**babcock & wilcox nuclear energy**

Subject: Babcock & Wilcox Nuclear Energy, Inc. (B&W NE) Response to NRC Request for  
Additional Information

Babcock & Wilcox Nuclear Energy, Inc. Response to  
Requests for Additional Information No. 6236  
RAI Letter No. 4

B&W mPower Pre-Application Activities  
Docket No. PROJ 0776  
Topical Report 08-002089-001

**Figure 5.1: Setpoint Relationships – For Increasing Setpoint (Similar for decreasing setpoint, but process is decreasing towards the setpoint).**

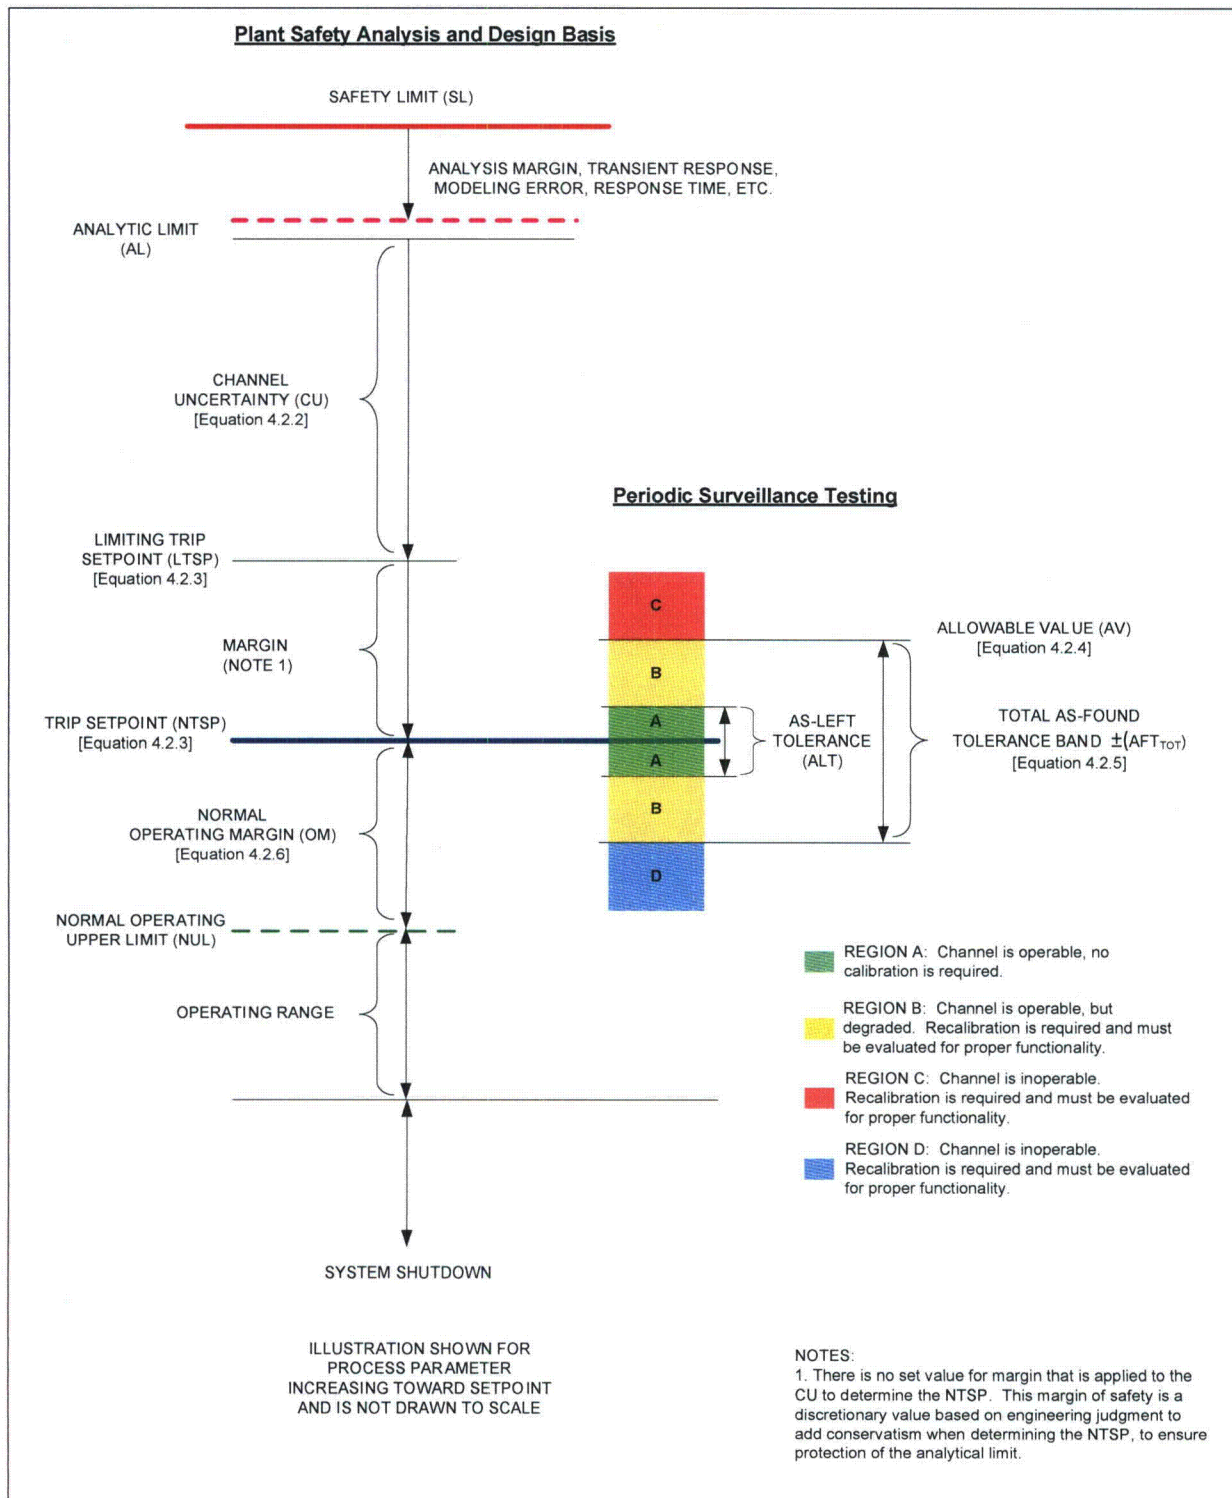
**Figure 5.1** - This figure shows Margin (Note 2) added to the setpoint calculation.

The staff requests that the applicant clarify the use of margin in the figure and revise the figure to reflect both the +/- of AFT, ALT, and the location of Margin (Note 2) in relationship to NTSP, AFT and AV (see below).

**Sections 4.2.4, 4.2.5 and Figure 5.1:**

- Section 4.2.4 - How is  $AFT^{TOT}$  calculated as a +/- value and shown on both sides of NTSP on Figure 5.1?
- Section 4.2.5 - How is  $AFT_n$  calculated as a +/- value?
- Section 4.2.4 - Explain why the definition of Margin is different from Note 2 on Figure 5.1.
- Is Margin (Note 2) correctly shown on Figure 5.1? see bullet 1 above.
- What value of ALT would be used in Figure 5.1? (Refer to RG 1.105 Rev. 3 Figure 1, "E. Region of Calibration Tolerance")

To clarify the relationship between Margin and NTSP, AFT and AV a number of changes will be made to Figure 5.1 and the text contained in Sections 4.2.4 and 4.2.5 of the topical report.

Figure 5.1 will be updated to properly illustrate the application of a double-sided band for the  $AFT_{TOT}$  as applied to the NTSP to ensure consistency with revisions to equation 4.2.4 described above. Additional revisions and enhancements to Figure 5.1 (page 24) include the following and the revised figure is shown below:

- Addition of a double-sided band for the ALT to aid in determination of channel operability and be consistent with Figure 1 in RG. 1.105.
- Illustration of regions of different conditions that may exist during periodic surveillance testing to clarify status of channel operability and required actions (if any).
- Removal of the margin applied to the  $AFT_{TOT}$  and its associated note (Note 2). (To protect against the potential for masking of equipment degradation during periodic surveillance testing.)

**Appendix A Figure A.2** - The staff requests the applicant to respond to the following:

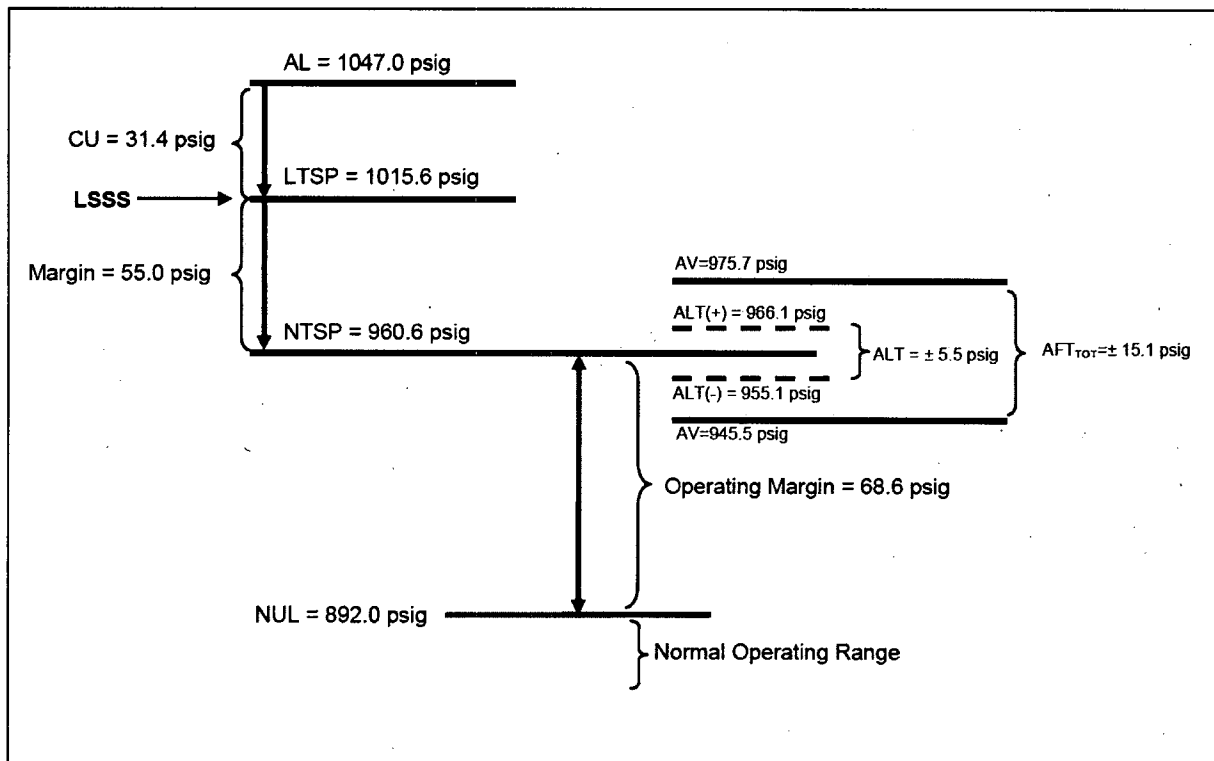
- Is margin correctly shown as 5.5 psig?
- Using example problem and Notes 1 & 2 from Figure 5.1, what would AV, Margin 2 and  $AFT^{TOT}$  be if Margin 1 is 5.5 psig (allowed by note 1) versus 55 psig?

Appendix A Figure A.2 contains a typographical error where the margin was incorrectly shown as 5.5 psig. The proper value for the margin as determined in this example is 5.0% of the span which is 55.0 psig.

Based on the revision to Figure 5.1 and section 4.2.4 discussed in response to Question 07.01-C Appendix-9, the relationship between the allowable value, as-found and as-left tolerances is more clearly understood. Figure A.2 has been revised to more clearly illustrate the relationships in the example between the AFT and ALT as shown below:
